RECORD OF SIGNIFICANT FINDINGS and ACTION PLAN.

ADDRESS: Grenfell Tower, Grenfell Road London W11 1TQ

COMPLETED BY: Mr C Stokes

DATED: 17th October 2014

GROUND FLOOR

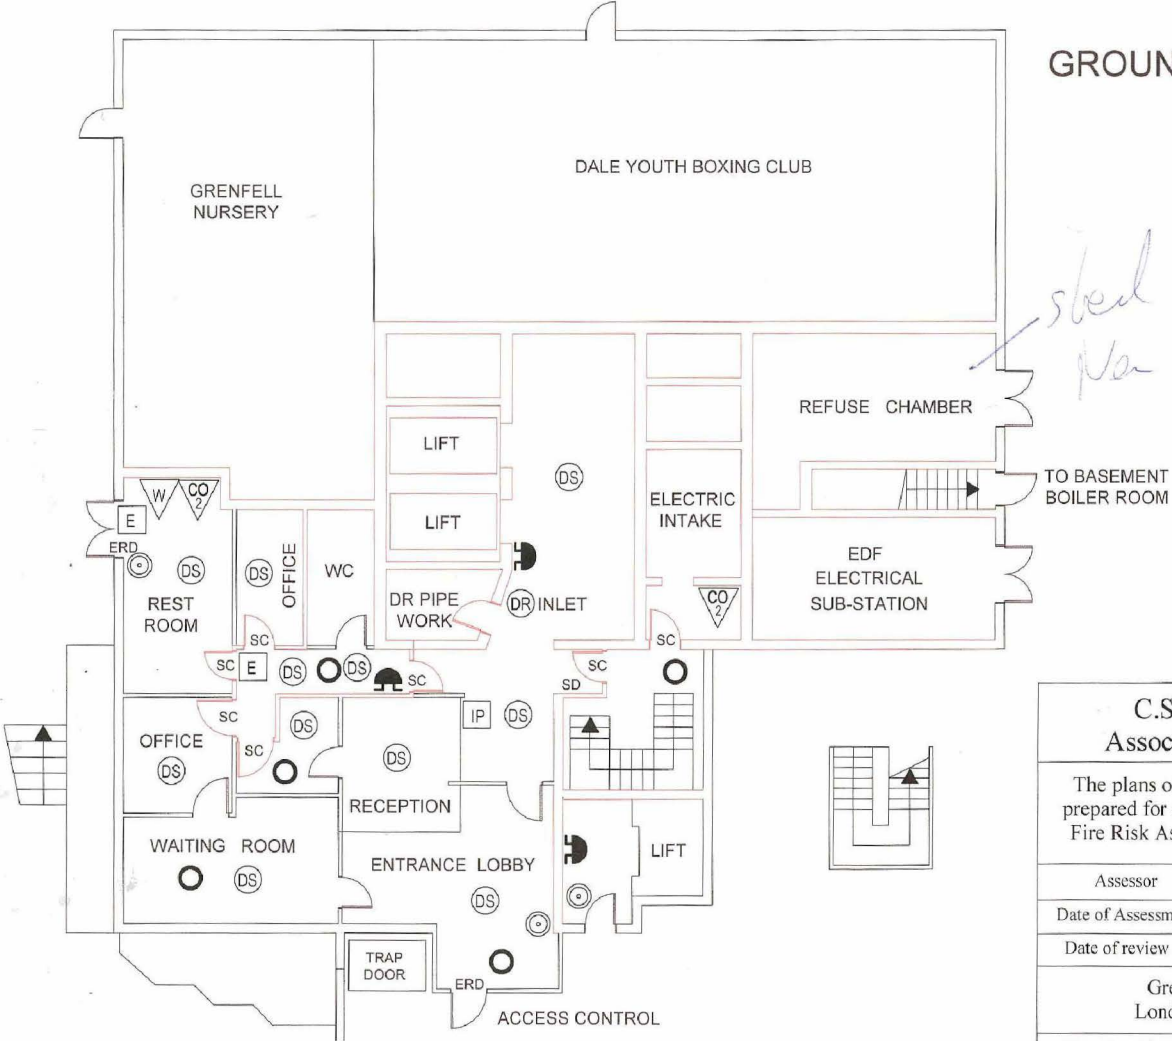
*steel plate
for metal doors*

4th FLOOR

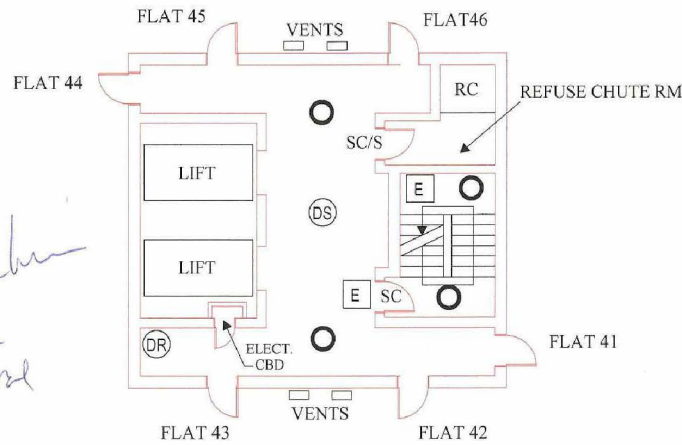
*Show as ~~not~~ see the Card
Down not shut see the Card*

*Repair work between 3 & 4
New beam of duct
P D*

*New entrance Hall
Down challenges
Fire Access*

*Walking cabinet
fall to use
cable
signifying
walking
Exit sign ↑
should be
diminished.*

15th Floor

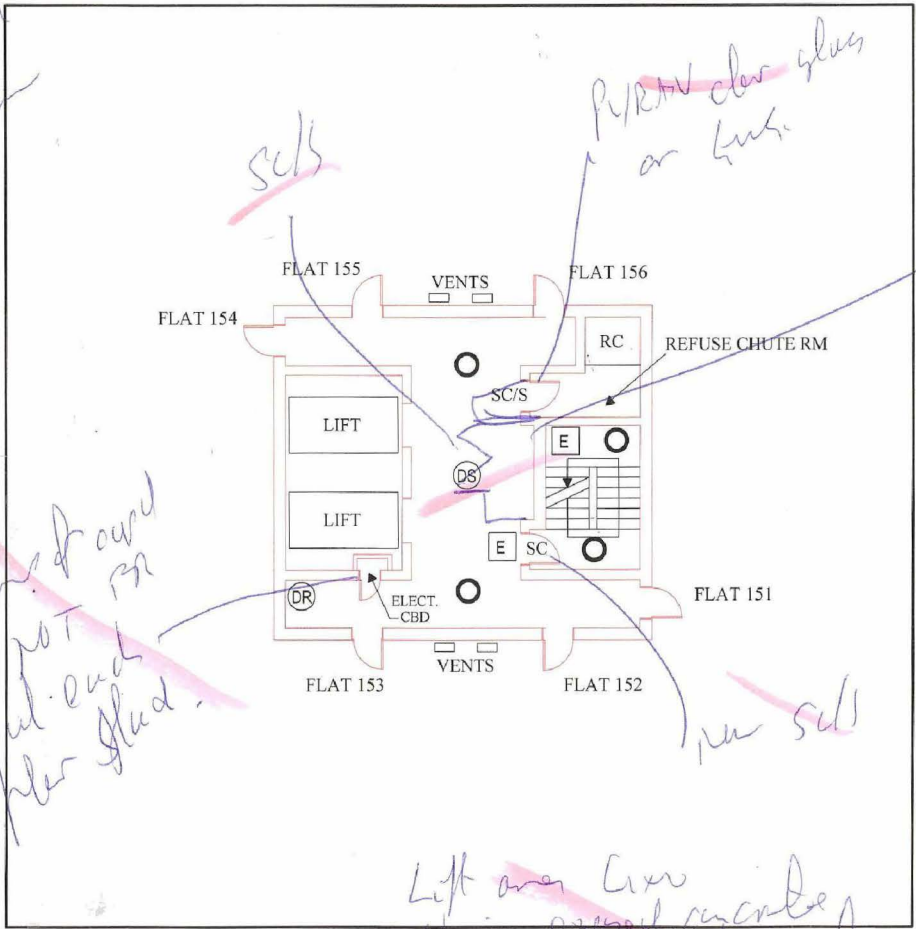
~~Sigs 14 Feb~~
~~15th floor~~
~~fire~~
~~and~~
~~where~~

~~Down of over~~
~~not~~
~~each~~
~~floor~~
~~glad.~~

~~new~~
~~15th~~
~~floor~~
~~used~~
~~5.1.11~~
~~floor~~
~~no~~
~~padding~~
~~will~~
~~Need~~
~~to~~
~~change~~
~~with~~
~~New~~
~~flurry~~
~~arrive~~
~~lift~~
~~floor~~
~~N²~~
~~Flat~~
~~N⁰~~

~~Lift~~
~~over~~
~~cur~~
~~stair~~
~~open~~
~~curtain~~
~~hall~~
~~but~~
~~metal~~
~~render~~
~~New~~
~~fire~~
~~curtain~~
~~install~~
~~special~~
~~alarm~~

Roof Level

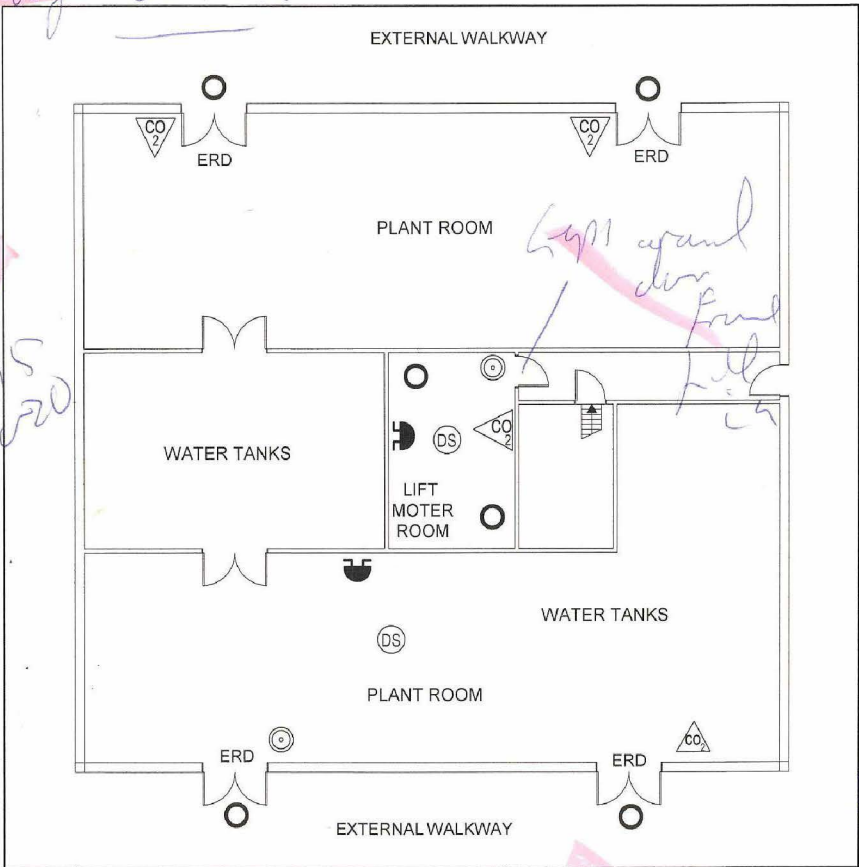
~~decks
stands
11-6-2015
6-2020~~

~~16-3-16
Lifts~~

~~out the lift
CITRSD~~

~~Water tanks
control
relief tanks
at this level~~

~~Hold
with
1-11-11~~

~~ADD BT
Turf storage~~
